**COMMUNITY DEVELOPMENT DEPARTMENT
PLANNING DIVISION
STAFF REPORT**

TO: Design Review Board
FROM: Planning Staff – Jeremy Hammar, Senior Planner
DATE: January 23, 2025

RE: Gig Harbor Fire & Medic One, Station 51 (PL-DR-24-0017)
Public Meeting Date: January 23, 2025

SITE PLAN

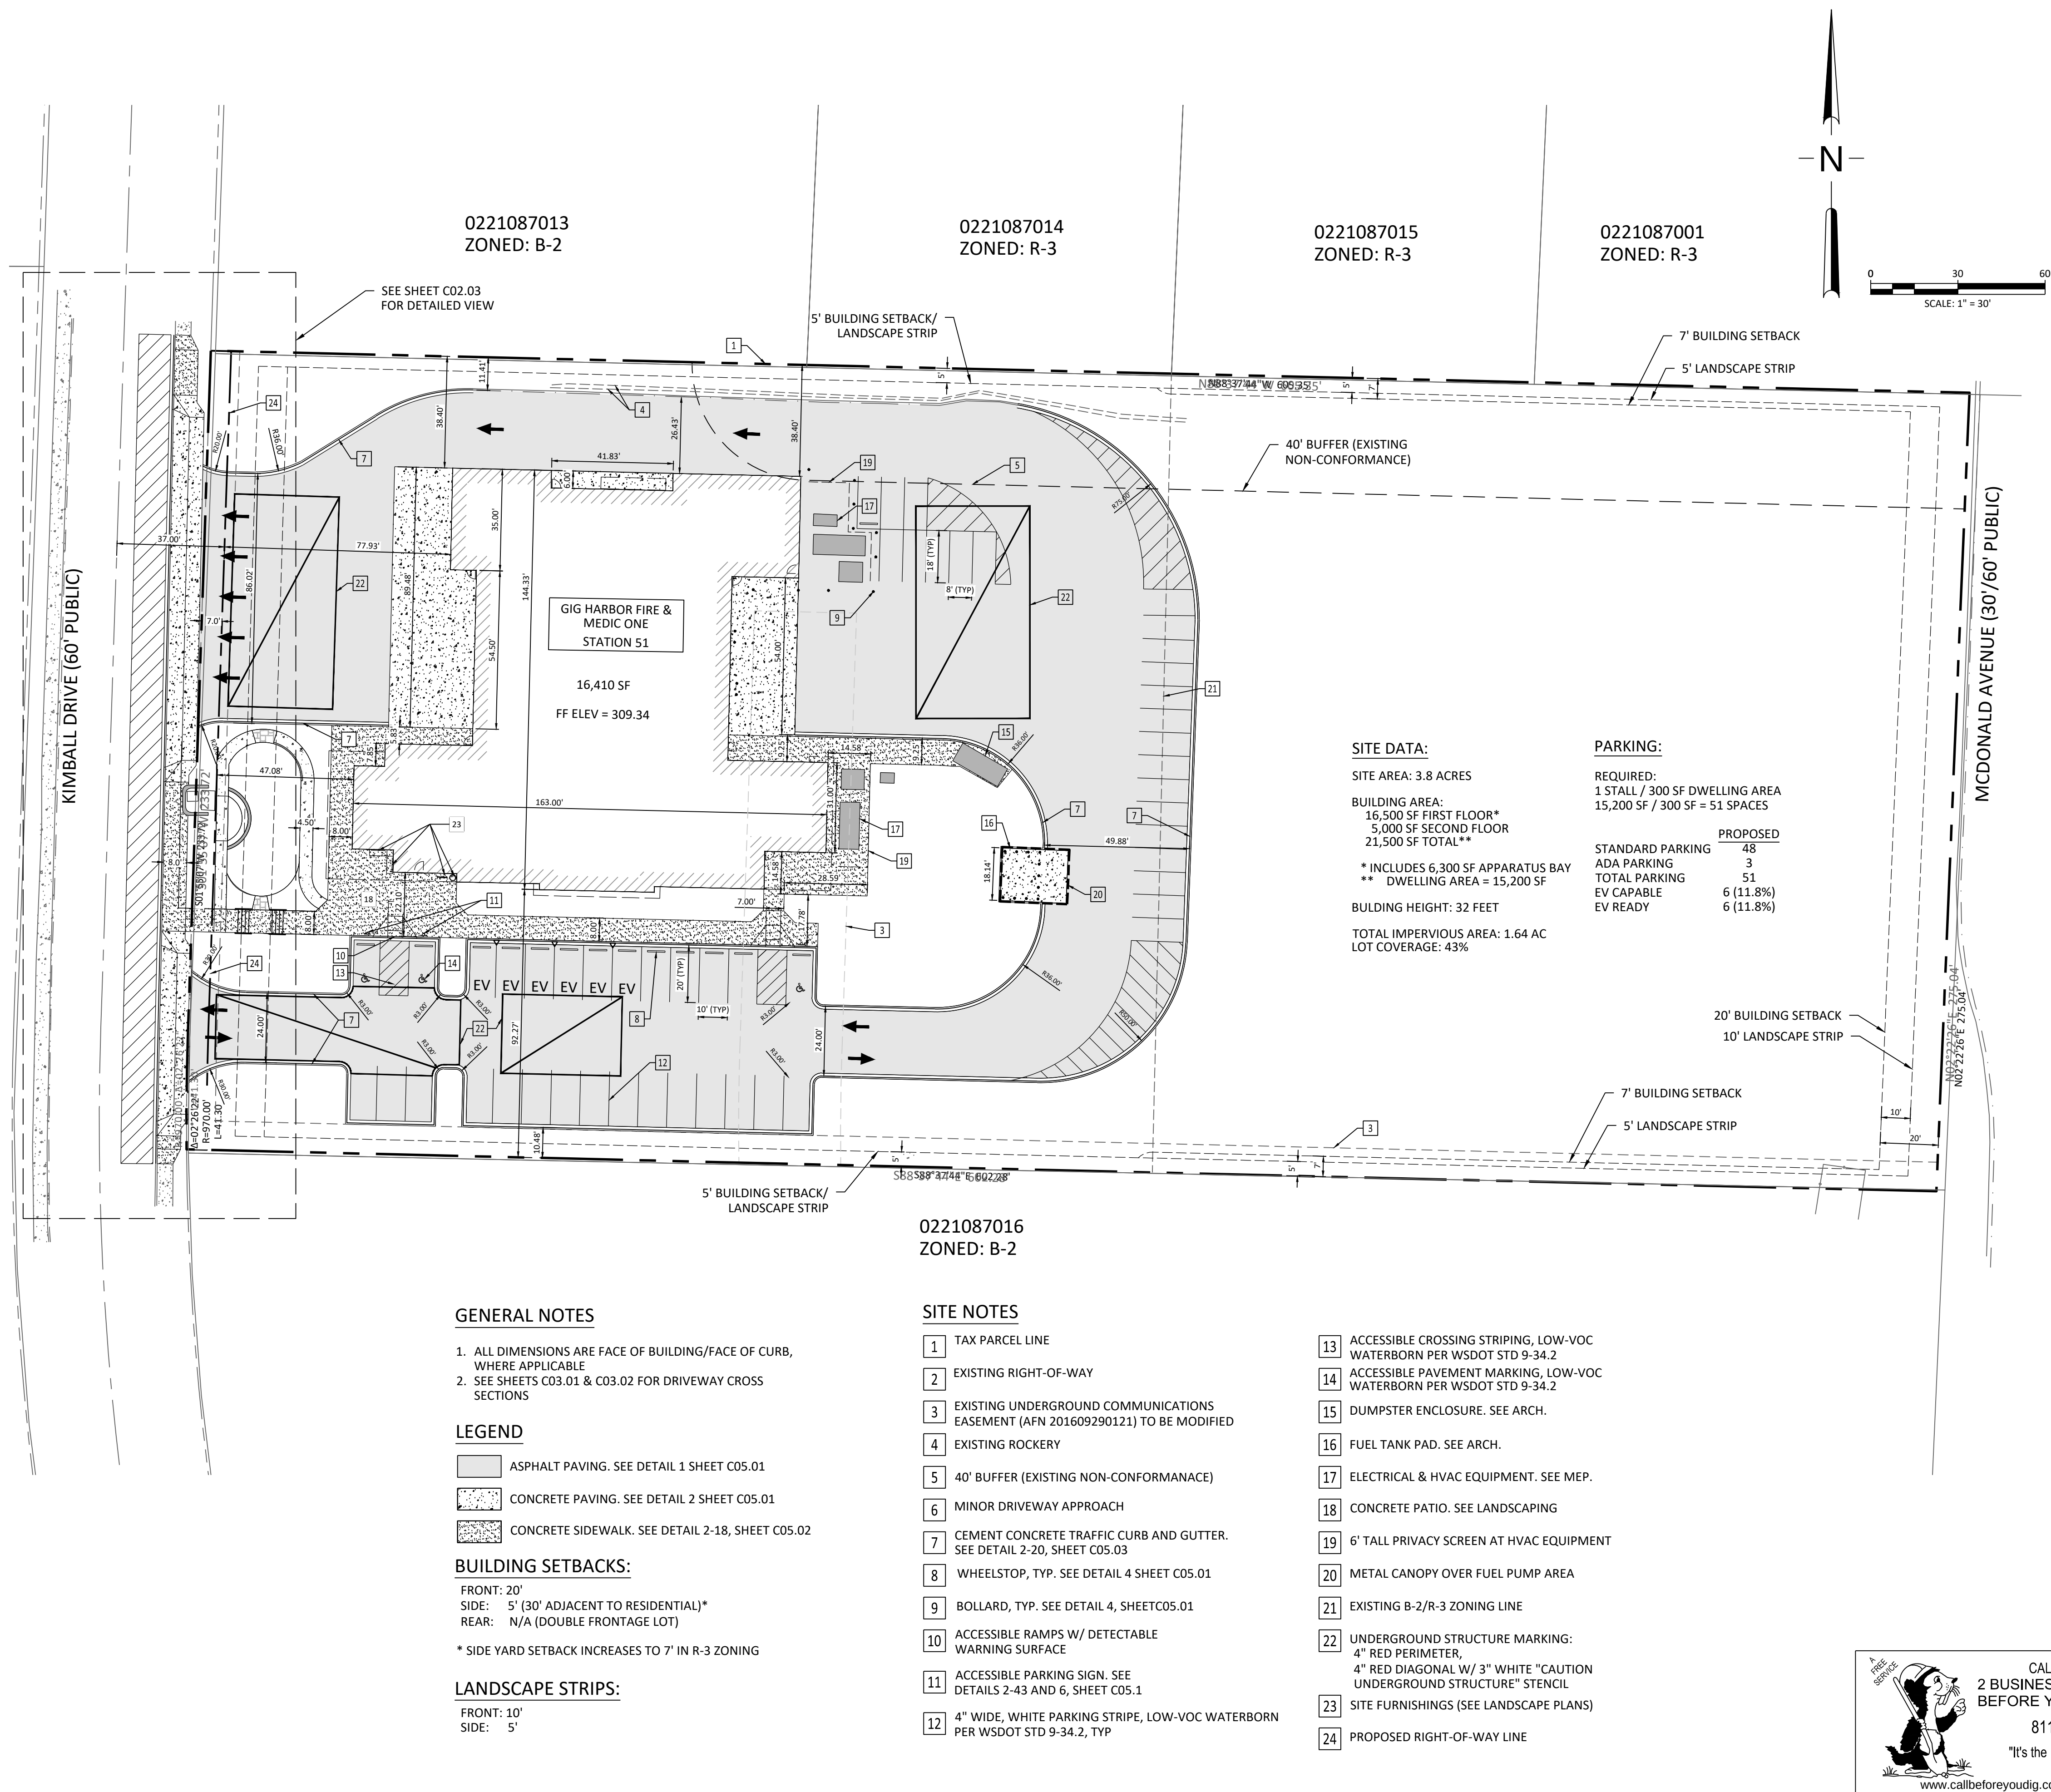
Full emergency vehicles access is desired on all sides of the building based on operational safety of the fire station. The access lane will be 6 feet lower than adjacent property based on the height of the existing rockery. Please refer to the attached Site Plan.

The proposed site layout preserves a stand of mature trees in the eastern portion of the property. Pavement surfaces will not be expanded to undeveloped portions of the site. Furthermore, ground plane English Ivy will be thinned/eradicated as part of landscape development for the project. Existing trees, which already provide an existing dense landscape buffer will be protected and preserved.

Reconfiguration of the proposed fire station would require clearing of mature trees in the eastern portion of the site. Further, it would do very little to provide additional screening given that the fire station site is 6 feet lower than the adjacent property.

02 BUILDING ELEVATIONS

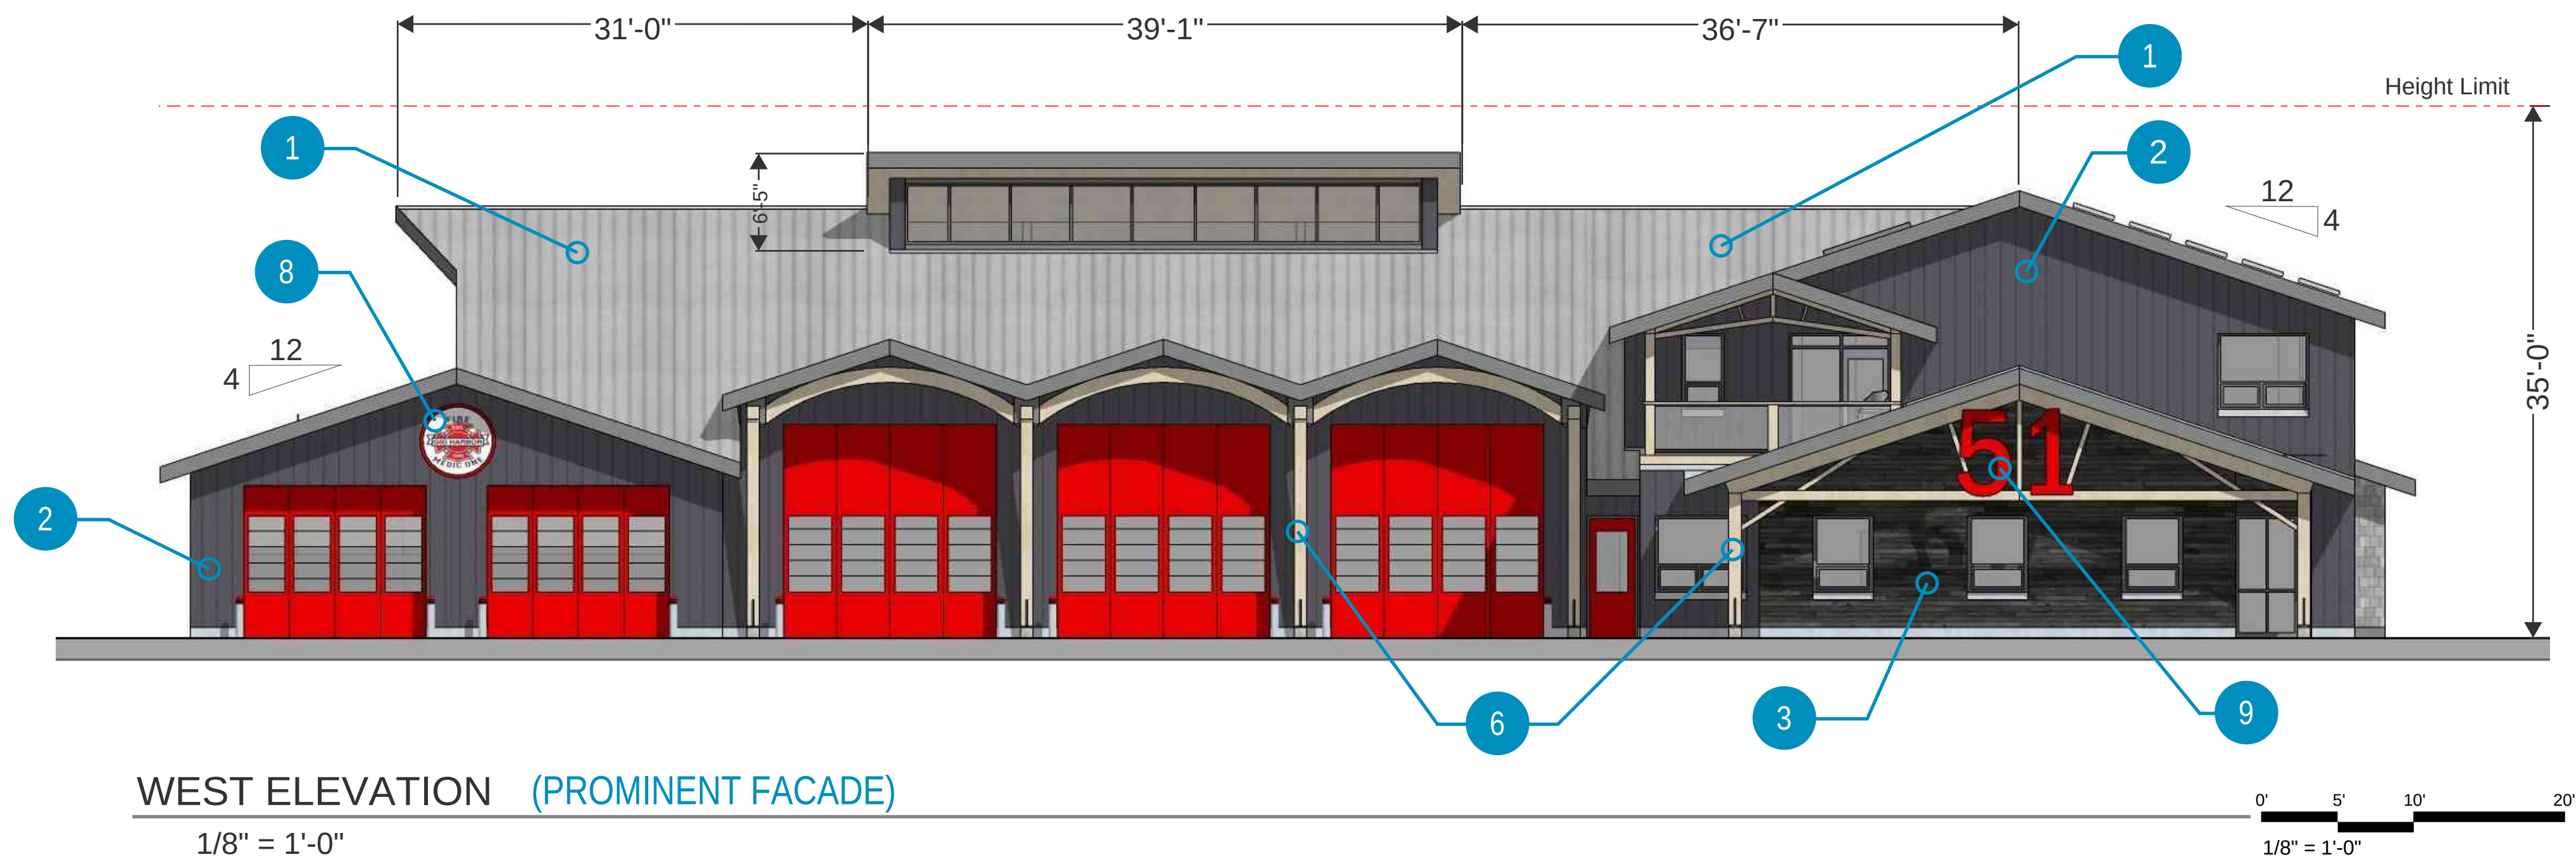
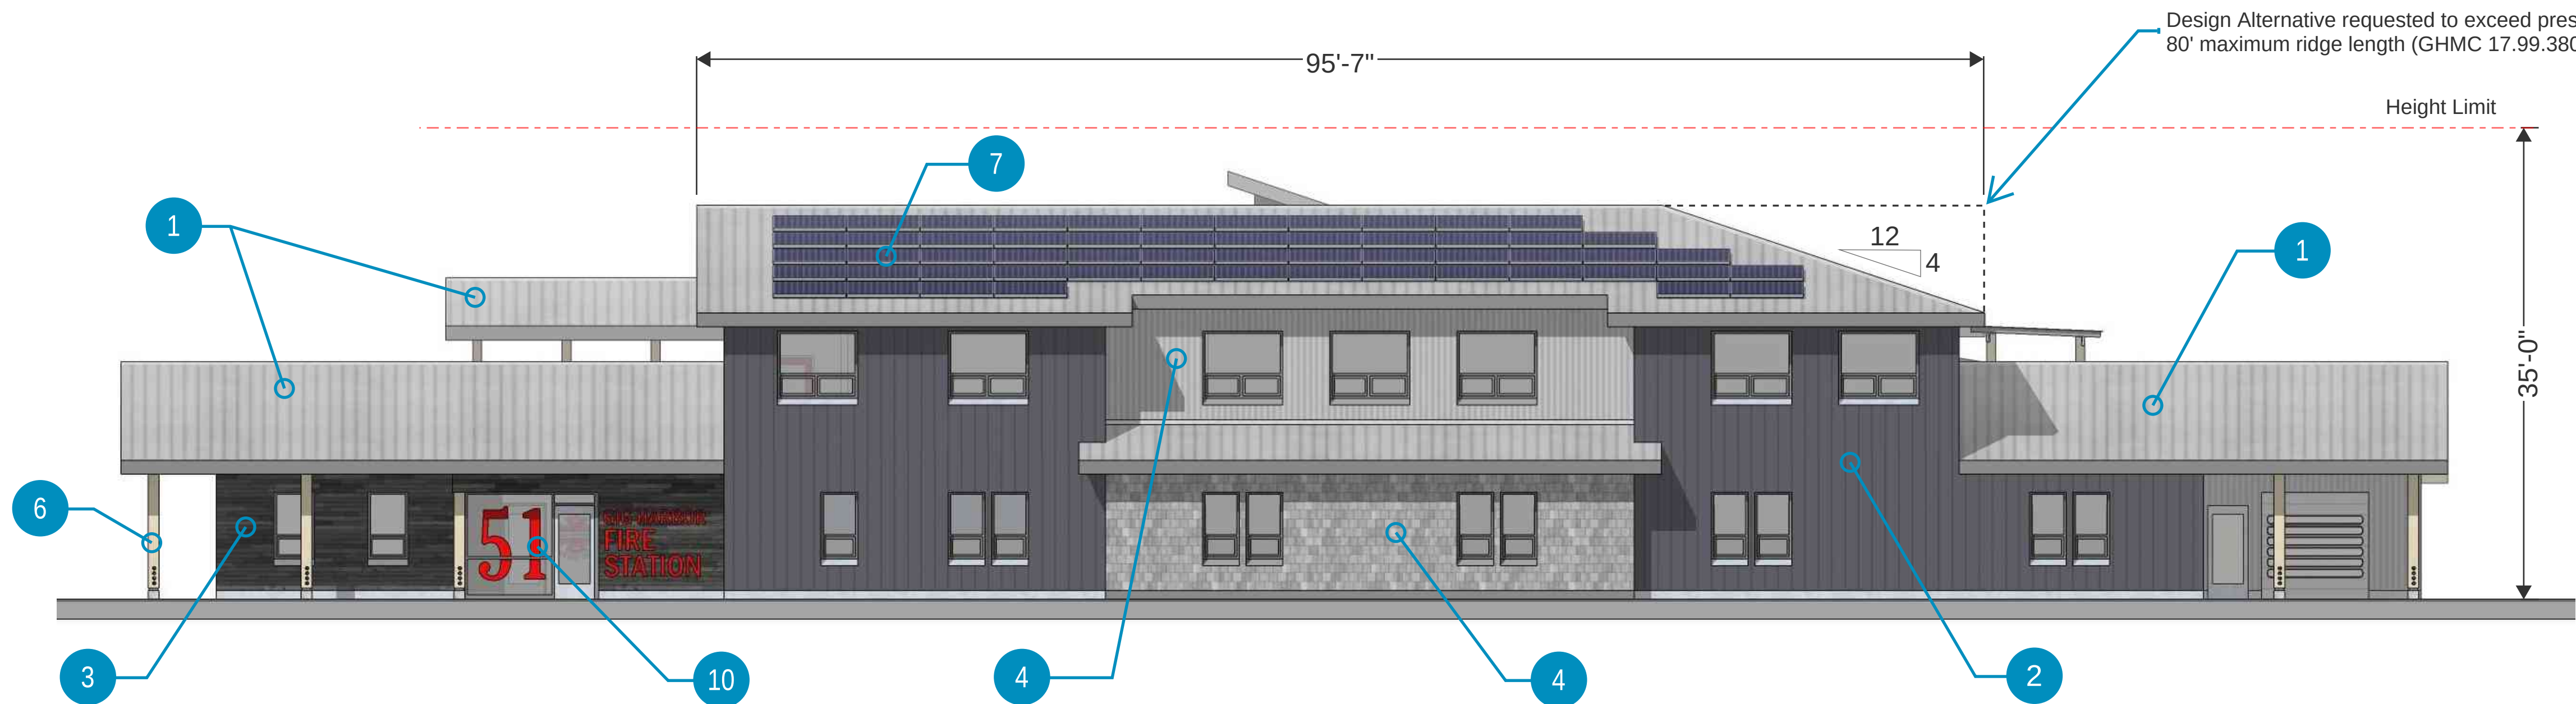
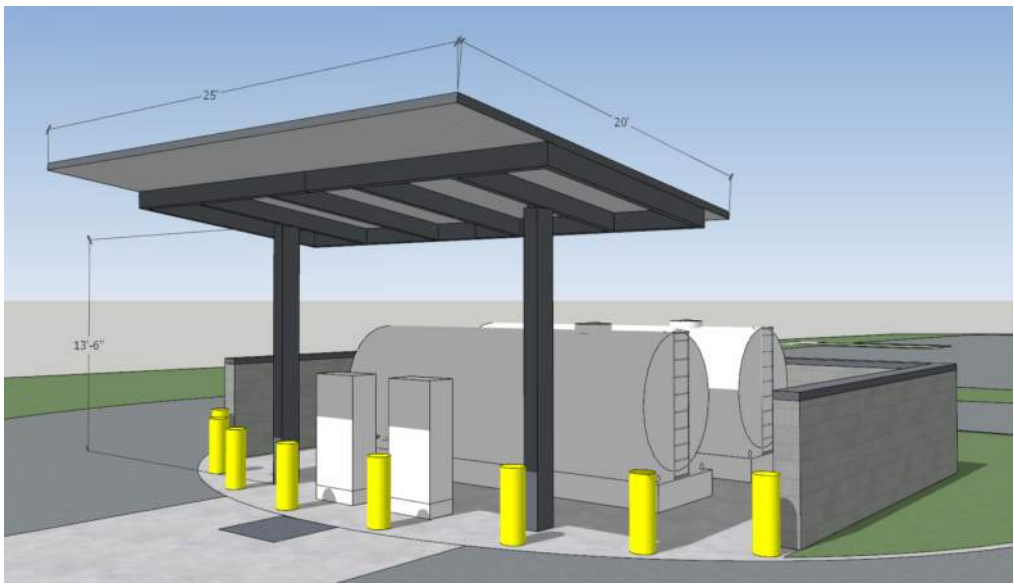
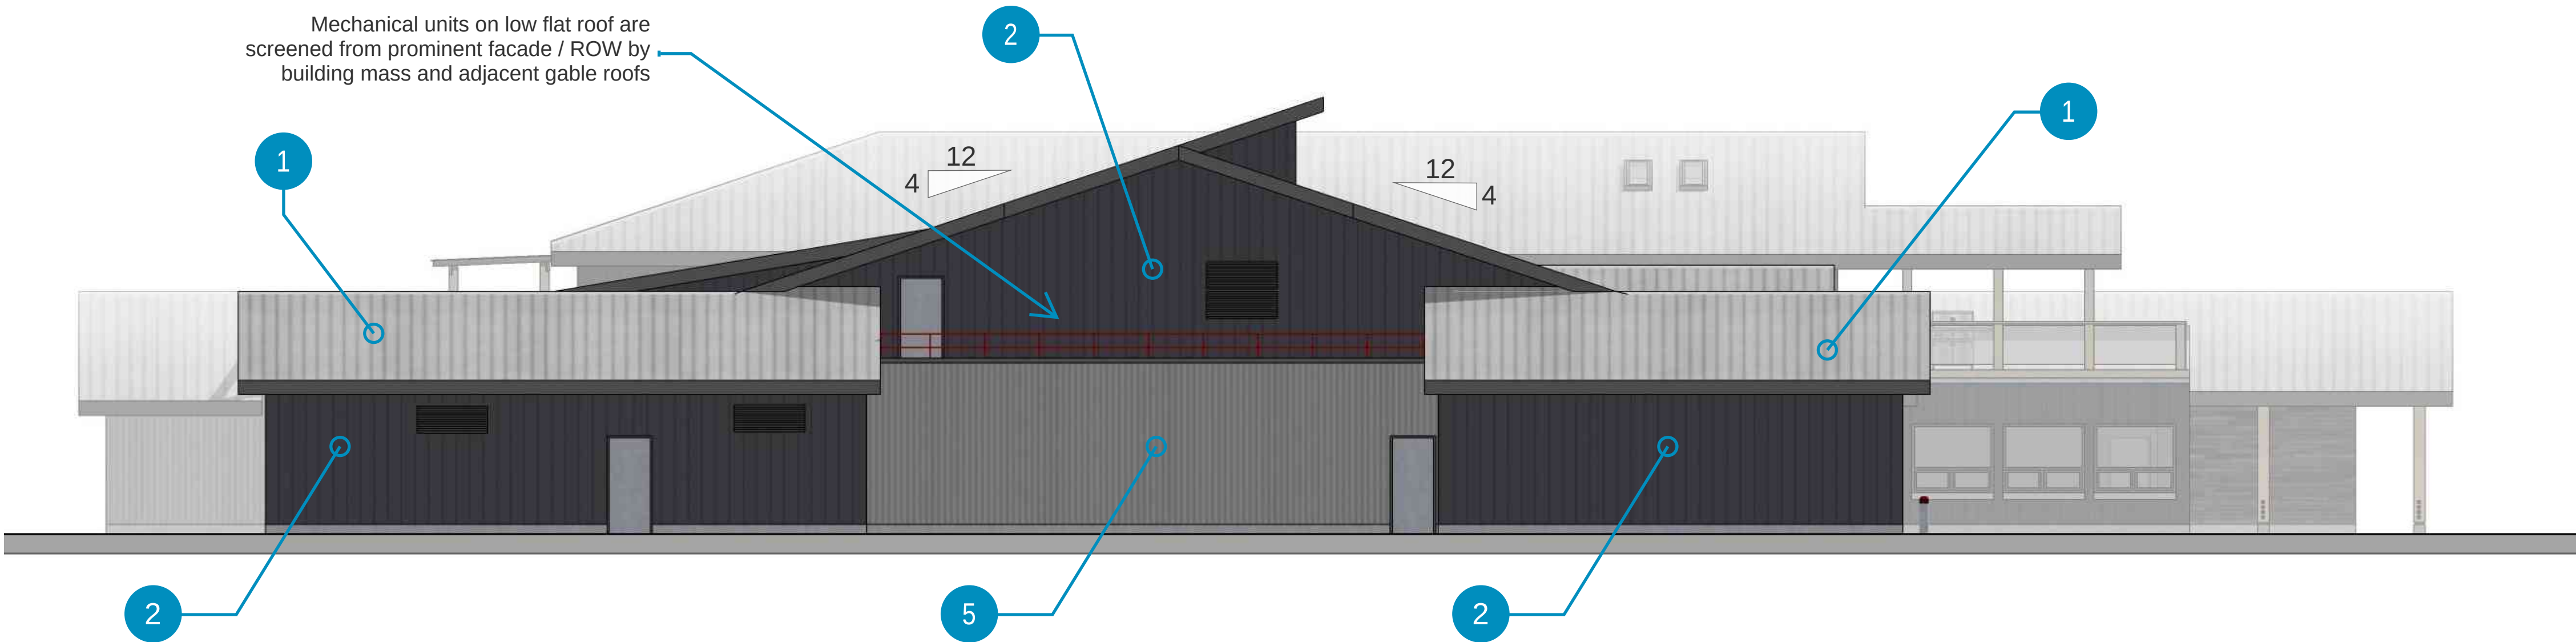
Gig Harbor Fire and Medic One proposes a design alternative to the vertical shifts in roof ridge for the replacement fire station no. 51 at 6711 Kimball drive. GHMC 17.99.380.B.2 states that that “*no single run of ridge...shall exceed 80 feet...*”; however, the proposed design would exceed the prescribed minimum ridge length by roughly 15 feet, in only one location, at the rear of the facility.

The proposed design meets the intent of the general requirements of the Design Manual, which is to “break down” wall and roof surfaces into smaller planes to then facilitate an appropriate sense of scale and proportion, and to help prevent unrelieved building masses which would run counter to the intended sense of place that the Design Guidelines are seeking to foster. The proposal seeks to fully embody the spirit of the design guidelines as an integral architectural aesthetic and not simply through the applique of components onto a box for minimal compliance.

On a functional note, the affected (non-primary) roof face is the most effectively orientated and elevated plane for efficient placement of a photovoltaic array to comply with the updated energy code requirement for on-site, renewable power generation. The roof surface in question has the project’s optimal solar access and orientation, while having the least visibility from the ground. Potentially, a reduction in the most suitable installation area might necessitate compromises in the photovoltaic system location, performance, and visibility.

No windows are planned on the northern side of the building, which will face the buffer area. There is a utility balcony (low, flat roof) planned along the central portion of the building; however, the utility balcony does not front the buffer area. Please refer to the attached Building Elevations.
